## Memo

**Ref:** Response to Peer Review  
Proposed Commercial and Residential Development, East of  
County Road 10  
Proj. No: 2400-25

Our company has received comments from Stantec (October 27, 2025) regarding our Traffic Impact Study Report dated June 25, 2025, which was prepared for the proposed commercial and residential development adjacent to Fallis Line, east side of CR10 in Millbrook.

Correction to Existing and  
Background Traffic Volumes Exhibits

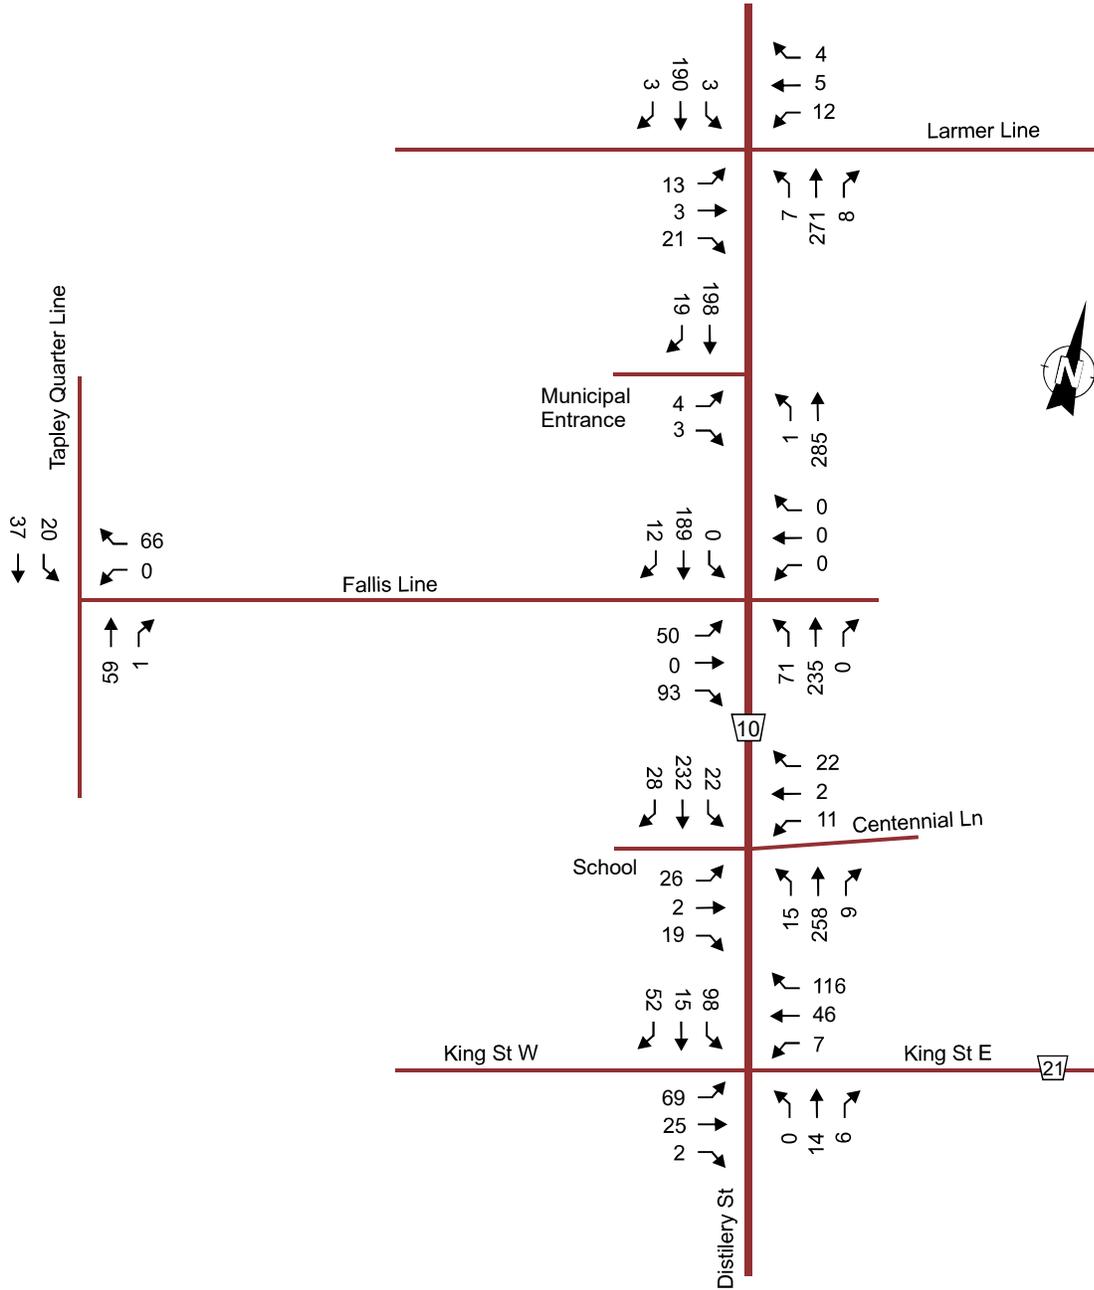
**Stantec Comment 7:** Exhibit 4 shows the intersection of CR 10 and Centennial Line/School Entrance as a T-intersection. Please revise this exhibit to reflect its status as a four-way intersection.

**Stantec Comment 11:** Future background volumes for the intersection of CR 10 & Municipal Access are not shown in Exhibits 8 to 16.

**Our Response:** Please see Memo *Appendix C*, which includes a revision of Exhibit 4.

**Our Response:** Please see Memo *Appendix C*, which includes the traffic volumes for CR 10 & Municipal Access depicted in the Exhibits.

# Super Convenience Market/Gas Station (960)

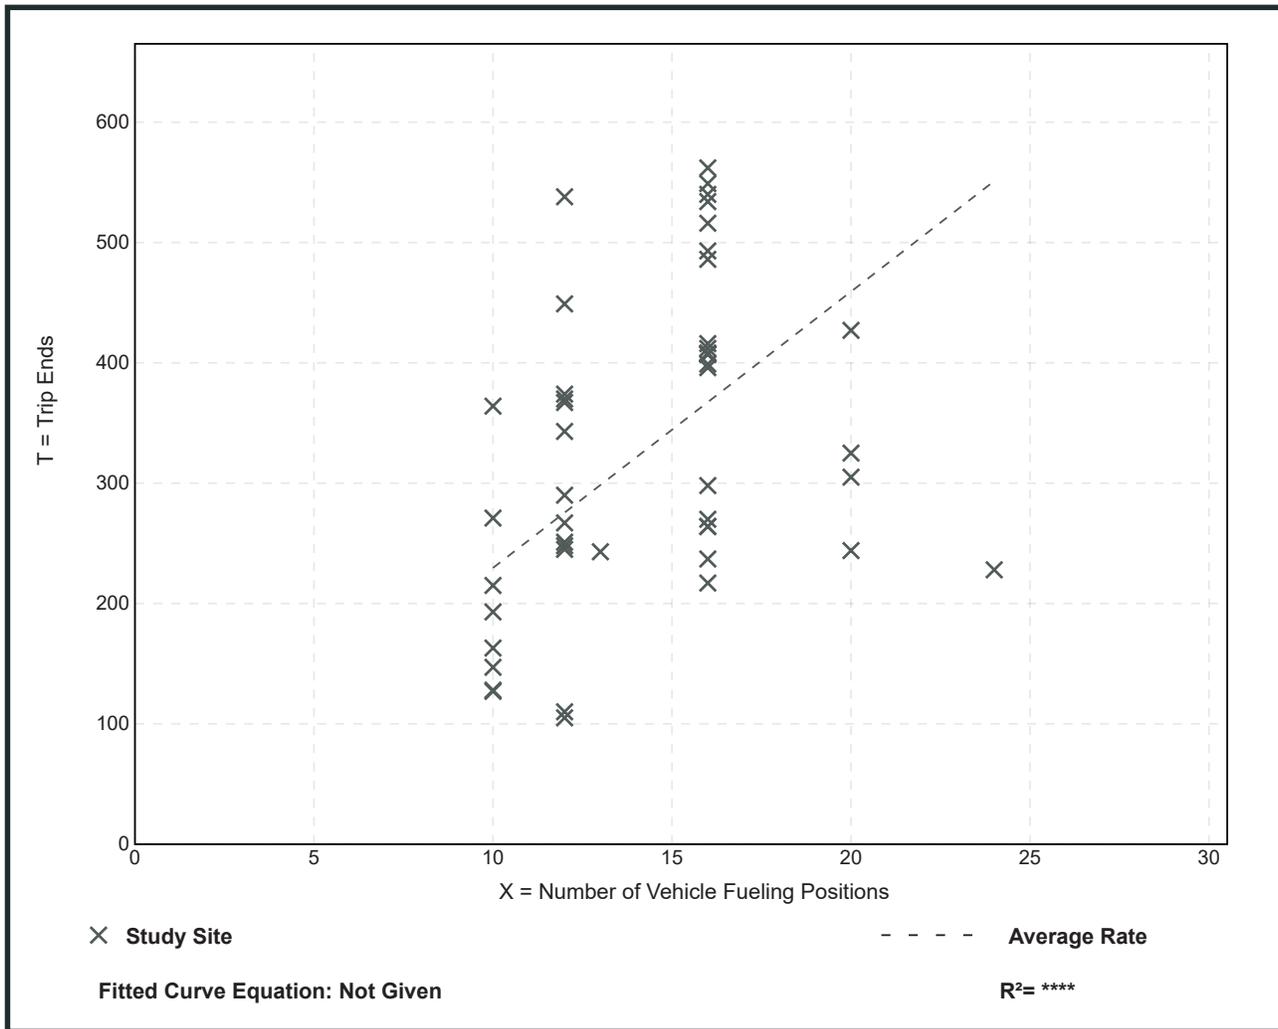
**Stantec Comment 17:** ITE LUC 960 reported for super convenience market/gas station. We were not able to find LUS 960 in ITE Trip Generation Manual and noted that ITE LUC 945 shall be used. The rates used in the TIS are also different from LUC 945 and should be revised.

**Our Response:** The data for LUC 960 is statistically sourced from the Trip Generation Manual, 10<sup>th</sup> Ed. In the context of the subject traffic analysis, we selected the use of Super Convenience Market/Gas Station; based on the study site descriptions provided by ITE, it provides a proper representation of the balance of convenience amenities to gas pumps than those found in the 11<sup>th</sup> Ed. for similar land uses.

Additionally, the data for LUC 960 represents a more conservative estimate of trips generated compared to LUC 945. The convenience market (2,500 sqft. GFA) shares its building with a quick service restaurant, thus the GFA 2-4k subcategory would be chosen for LUC 945. The difference in trip ends vs. vehicle fueling positions is as follows:

- AM Peak Hour: 28.08 (LUC 960) compared to 16.06 (LUC 945 – GFA 2-4k)
- PM Peak Hour: 22.96 (LUC 960) compared to 18.42 (LUC 945 – GFA 2-4k)
- SAT Peak Hour: 23.26 (LUC 960) compared to 17.01 (LUC 945 – GFA 2-4k)

For the excerpts depicting the trip rates for LUC 960 from the ITE Trip Generation Manual 10<sup>th</sup> Ed, see Memo *Appendix F*.

Left Turn Lane Warrants  
for Site Access Driveways

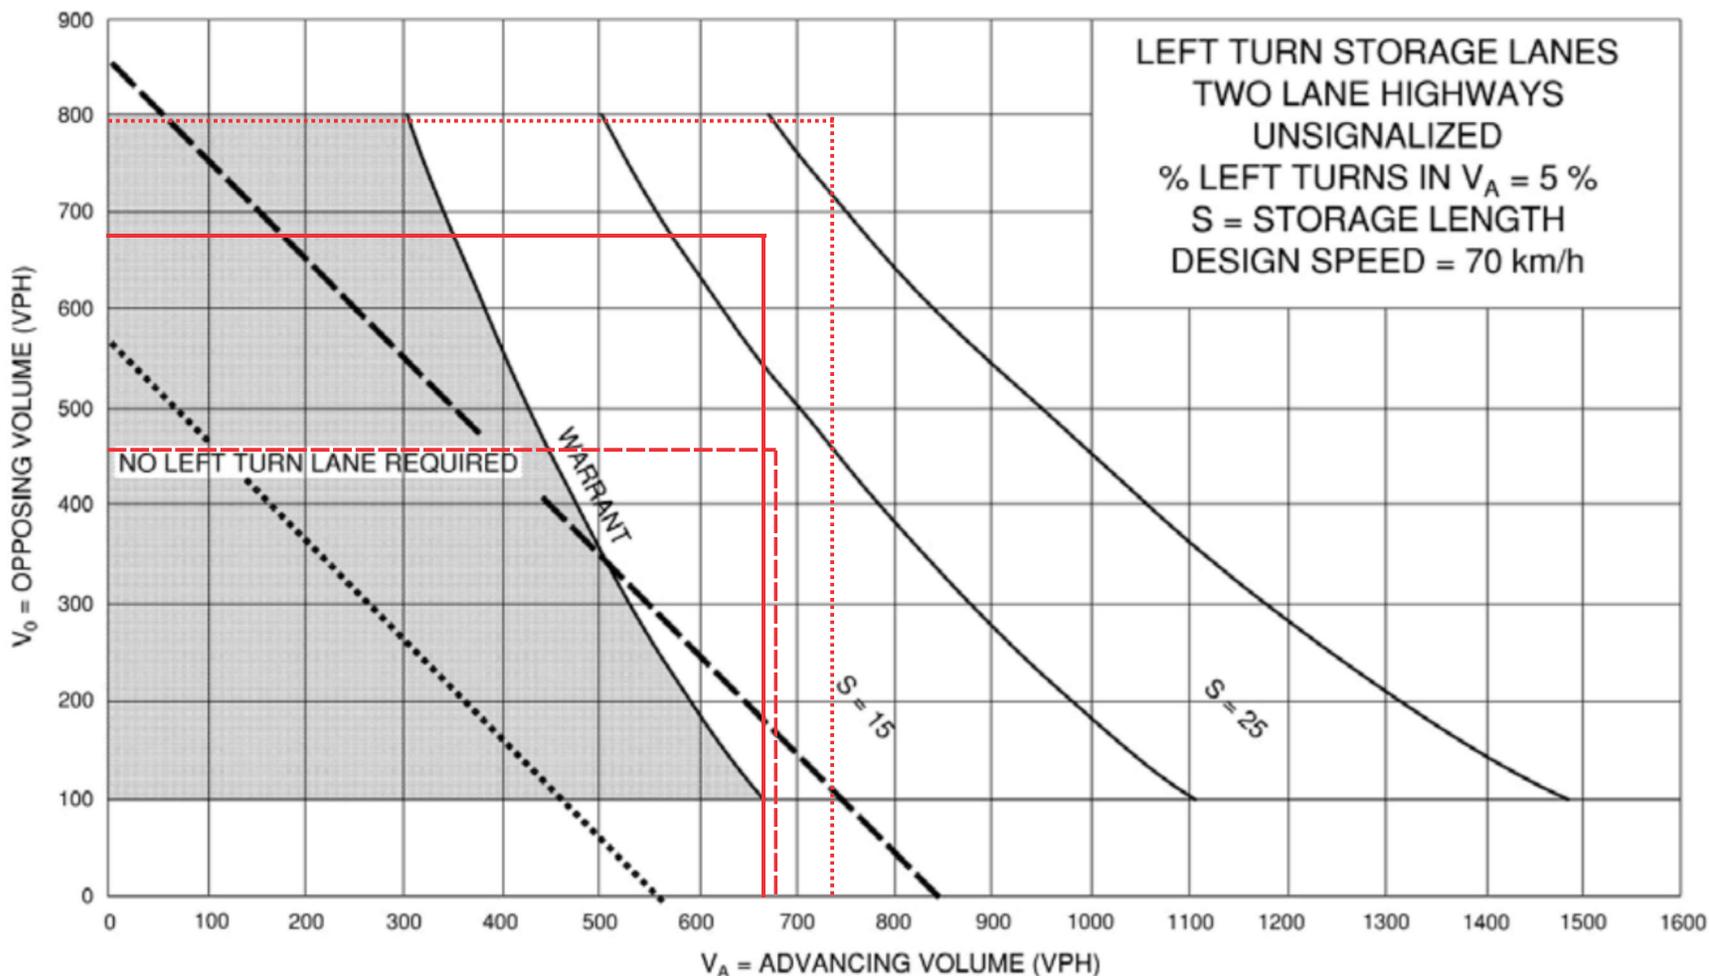
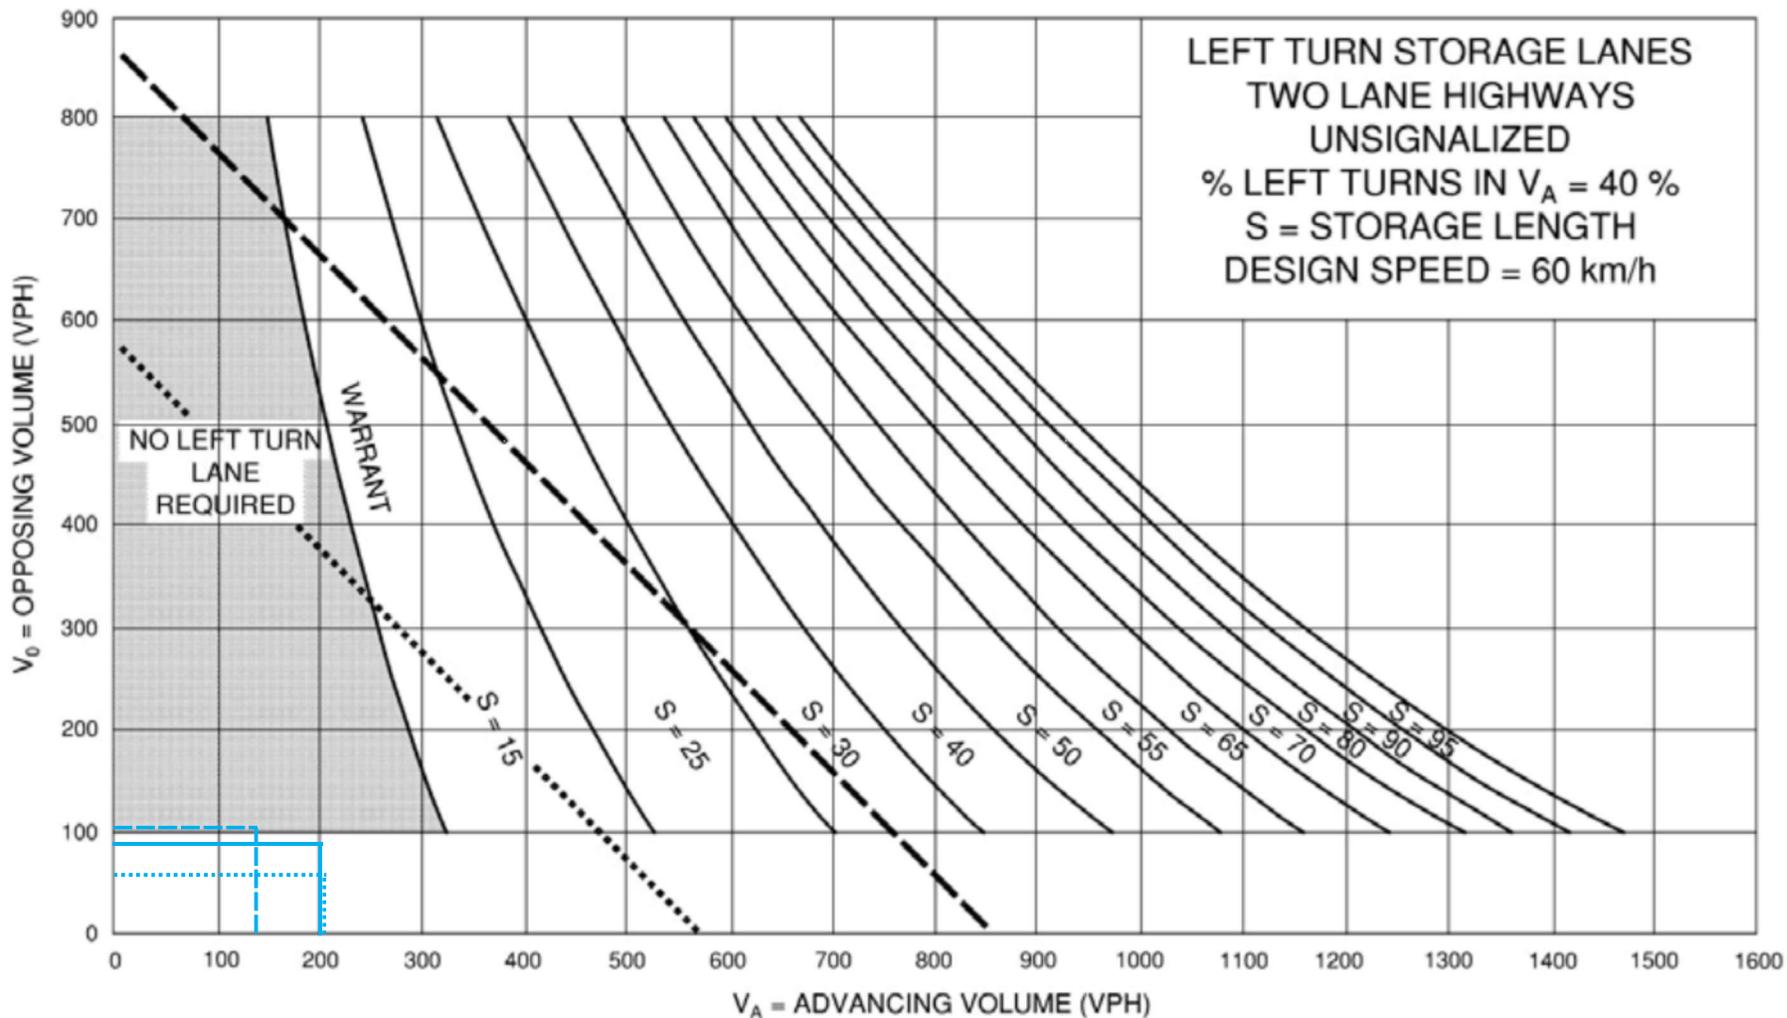
**Stantec Comment 29:** Provide left-turn and right-turn warrant analyses for all access drives. Appendix R only includes left-turn warrant analysis at CR 10 and Larmer Line for NBL and SBL movements.

**Our Response:** The left-turn warrant analyses for the higher-volume full-movement accesses are provided in Memo *Appendix H*. While it is not warranted, a left-turn lane at Fallis Ln & Dwy F is proposed due to the opportunity for optimal separation of movements. The application of auxiliary lanes regardless of the warrant is permitted and is a common practice for many developments of these types.
